New High School in Bungendore

State Significant
Development Application
(SSD-14394209)

Architectural + Landscape Design Report Addendum

Rev B
September 2022
Project No. 200096

1 Community Health Centre, Community Library, Council Shop Front

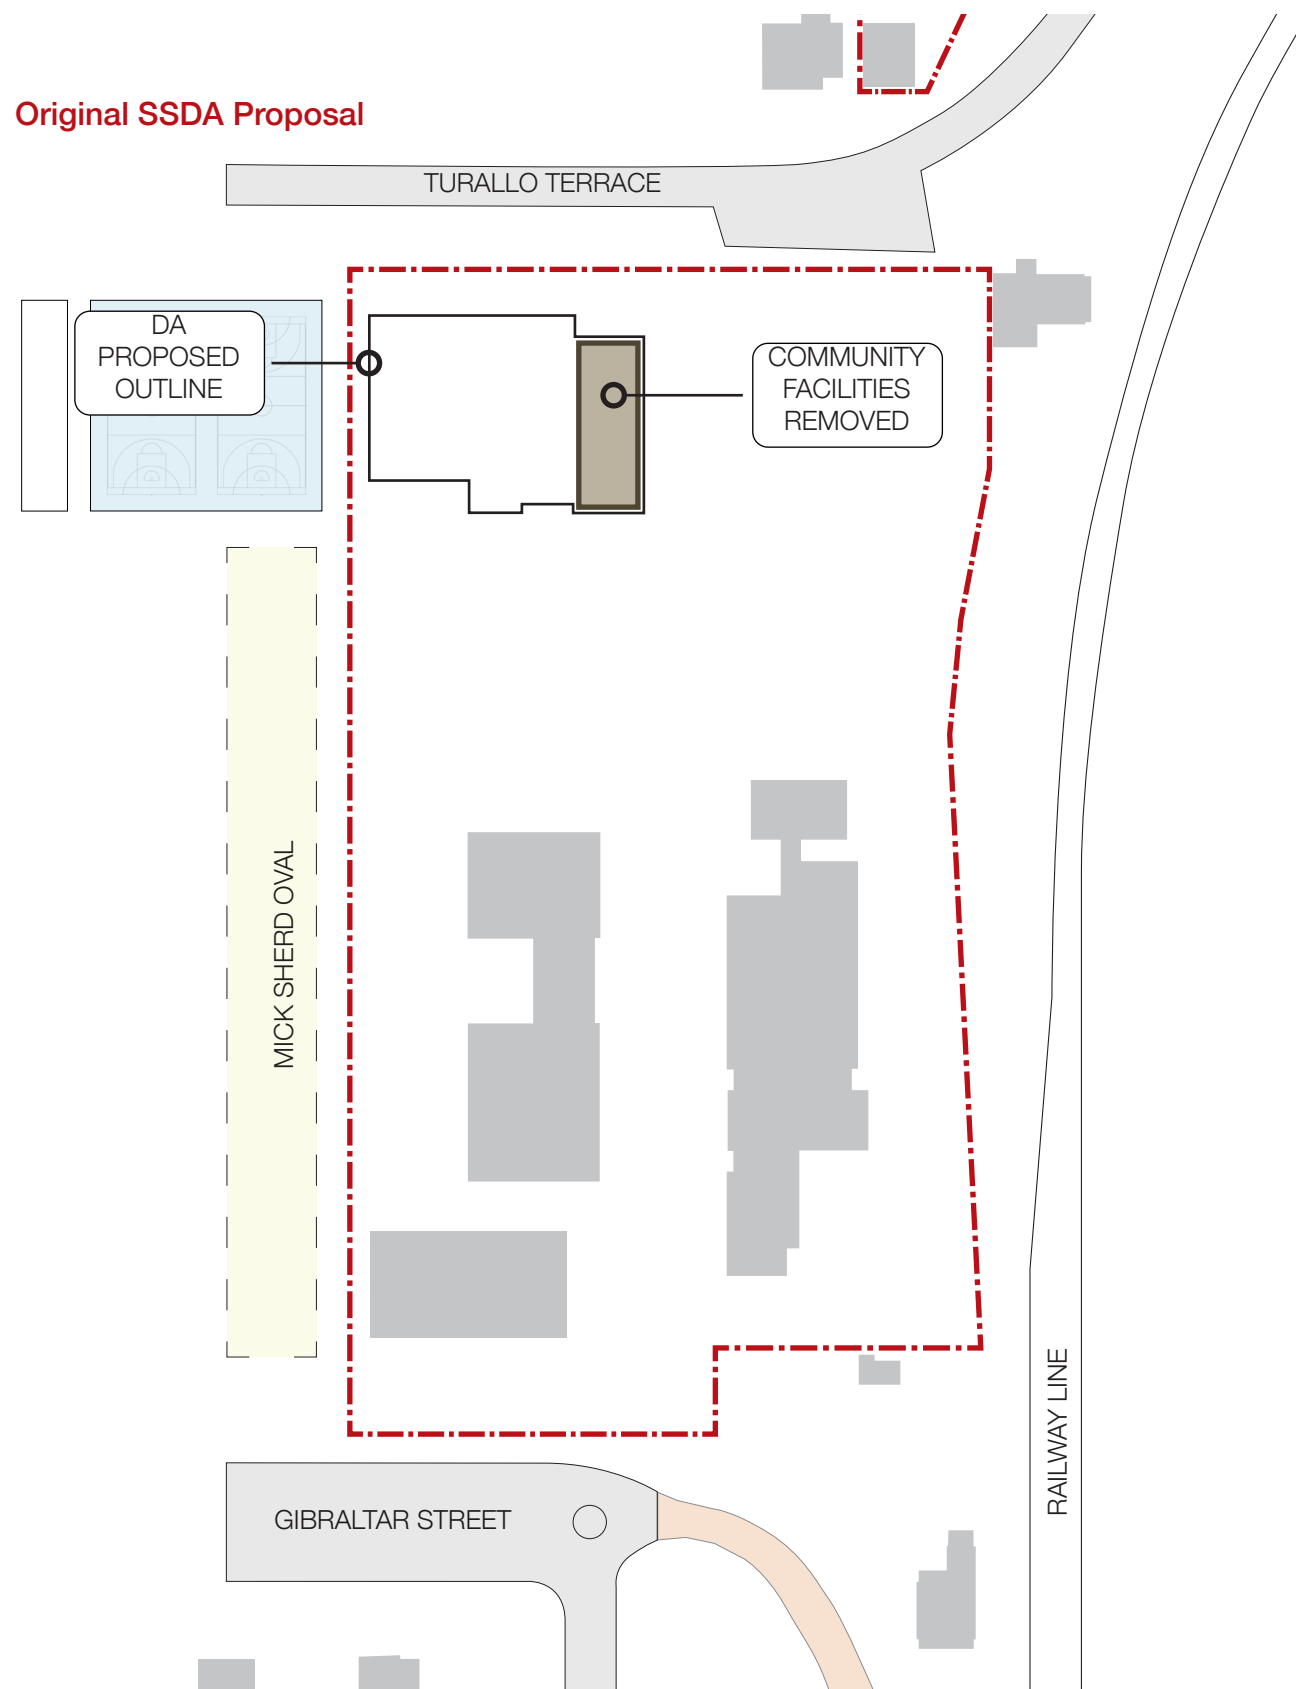
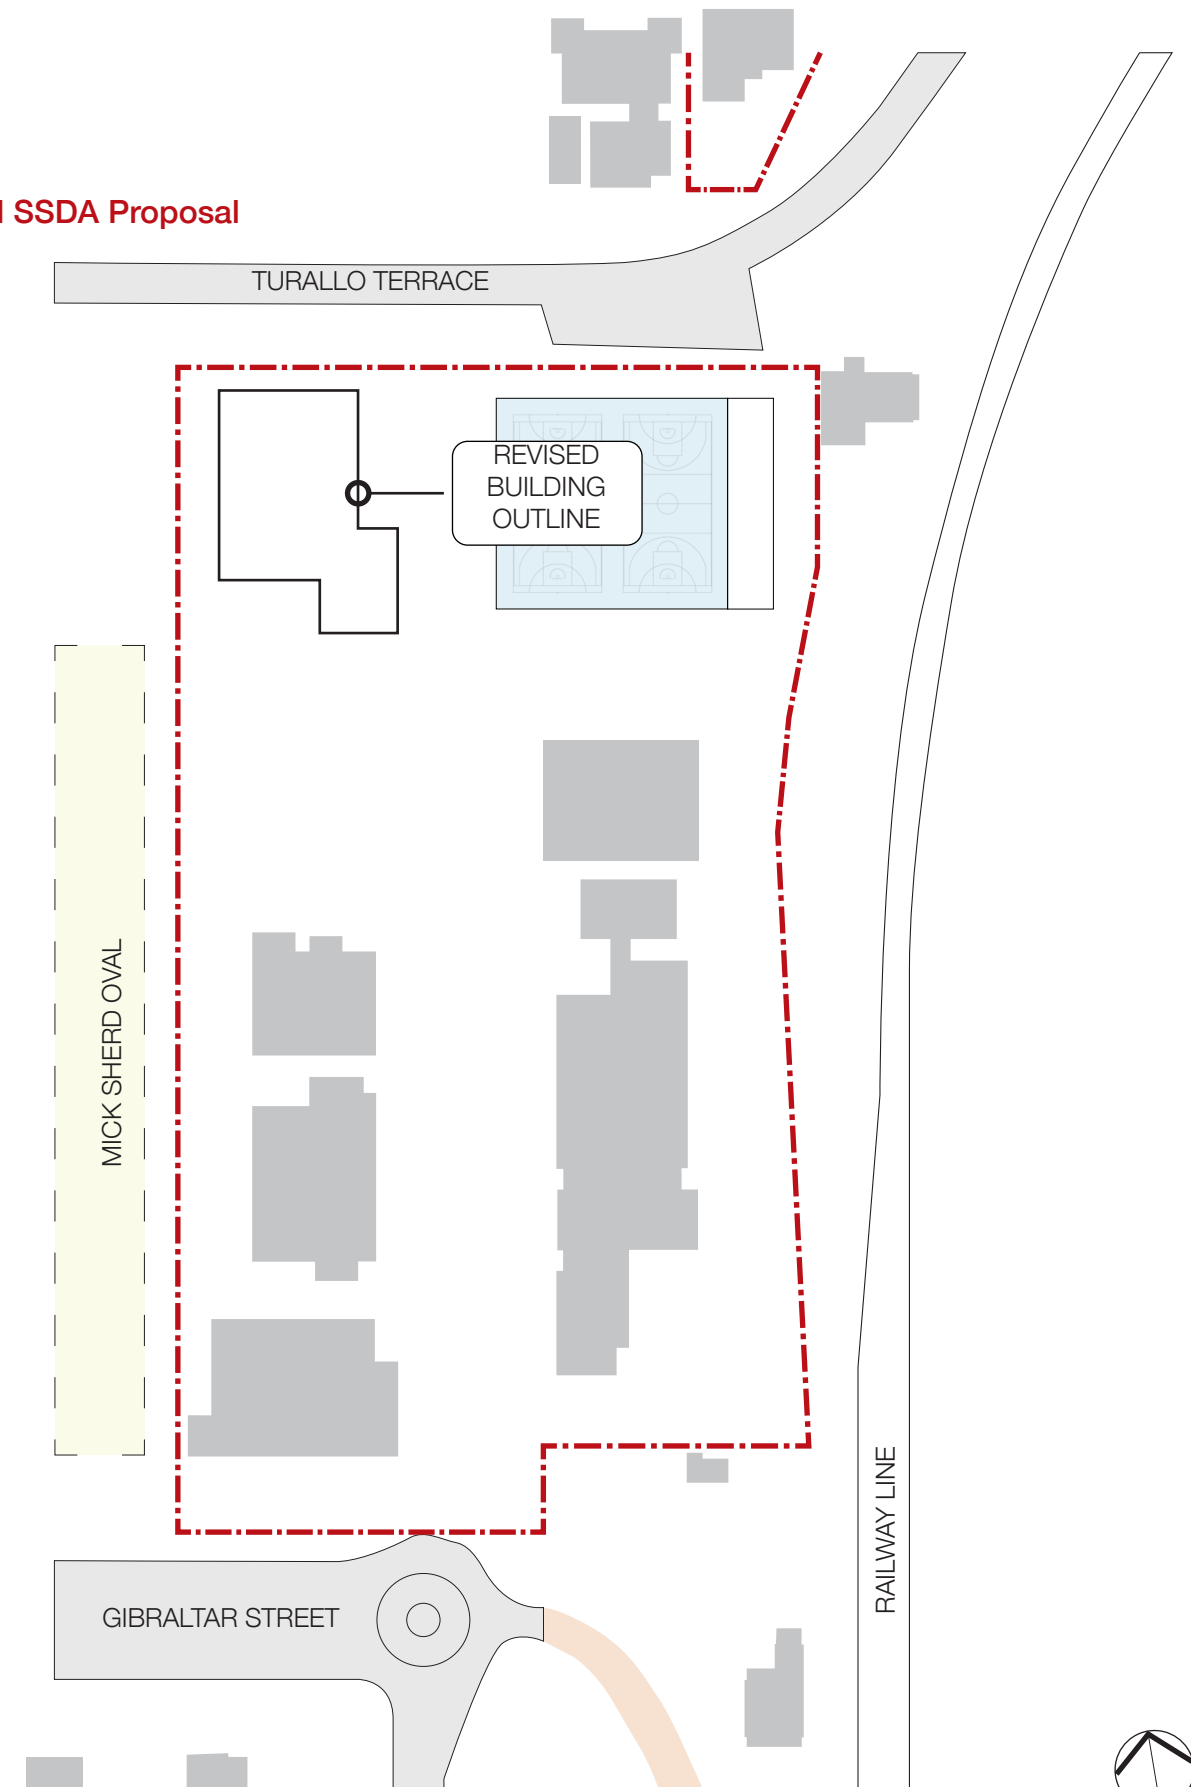
The Community, Heath Centre, Community Library and Council Shop Front have been removed from the proposal. These facilities are to be provided by Council through a seperate planning process on a different site.

2 Relocation of Administration and Staff Facilities

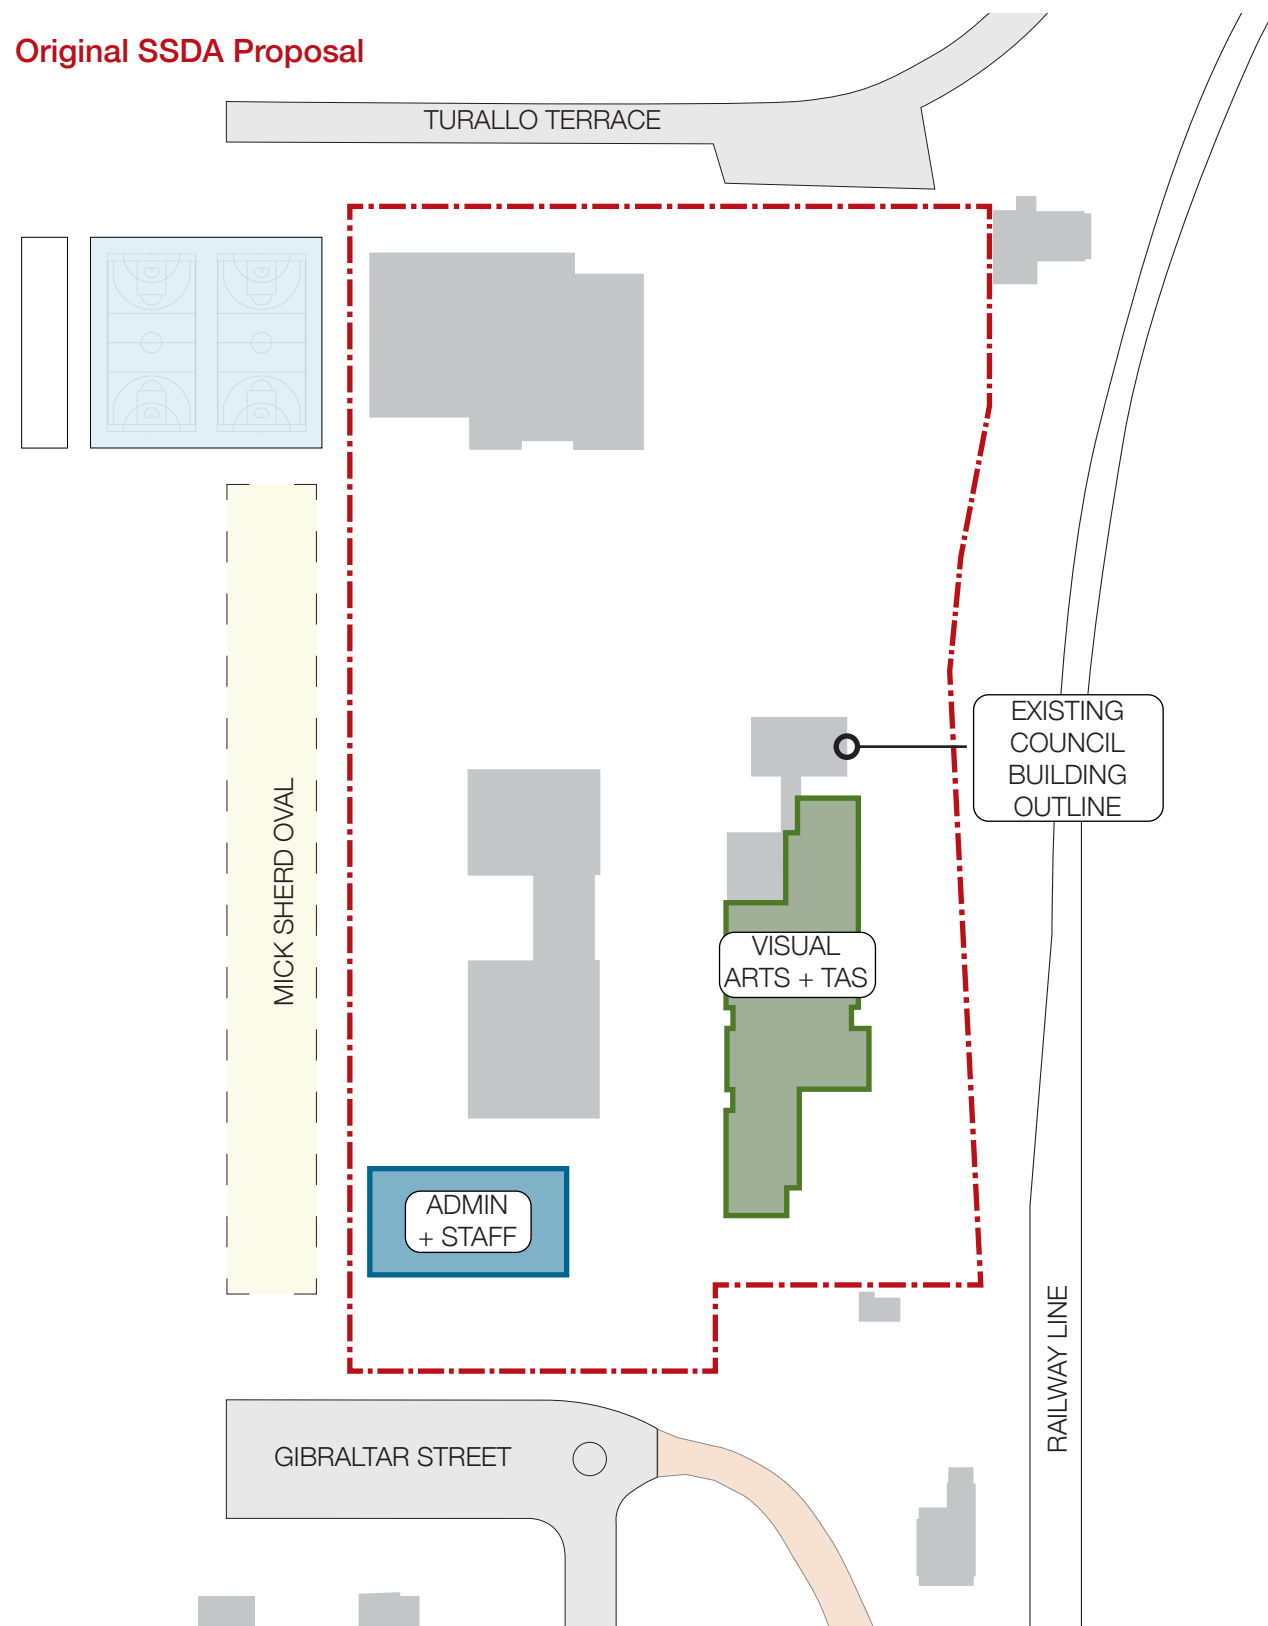
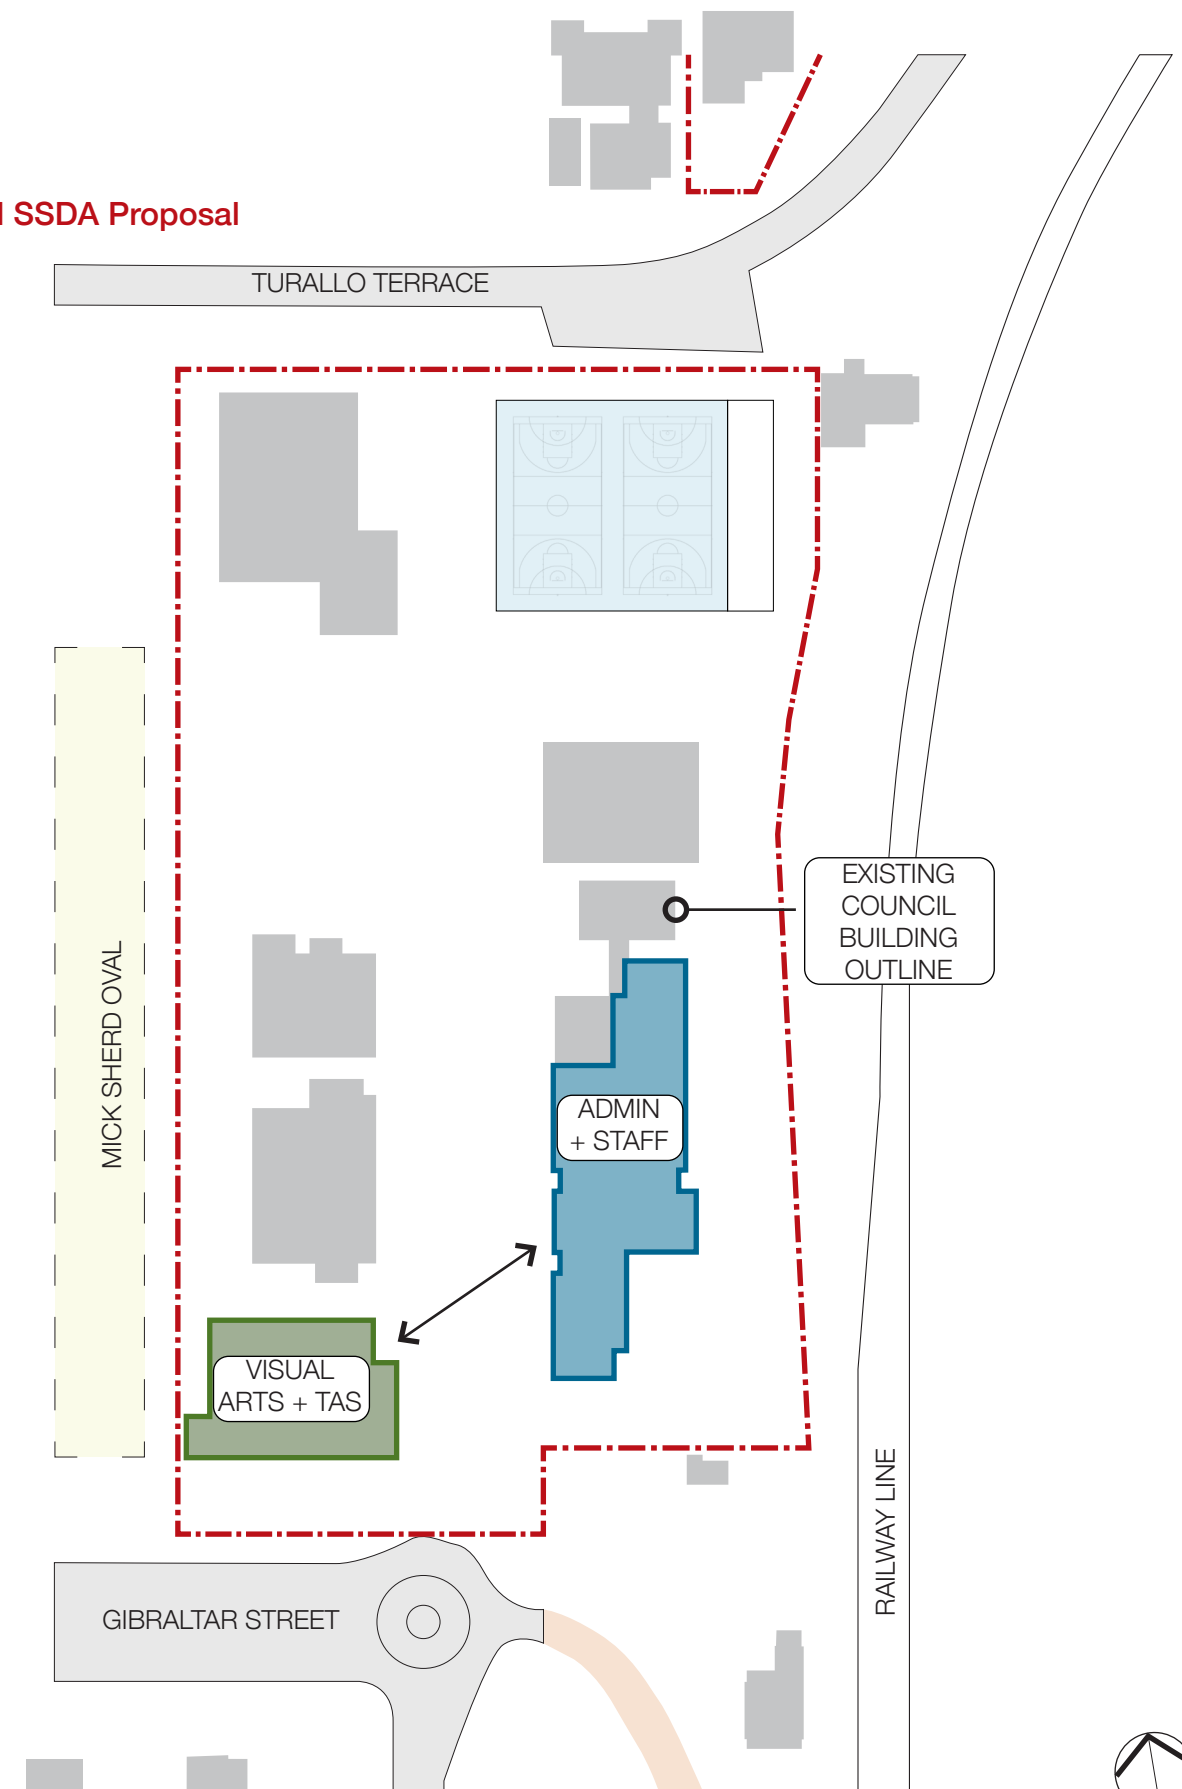
Block A Administration and Staff facilities have been relocated into Block C (existing council building) and Block C Visual Arts and TAS functions are relocated into Block A. The reuse of the Council Building for administration purposes achieves a sustainable outcome requiring significantly less intervention with the existing building fabric. The proposed Block A has been redesigned to suit the new functions.
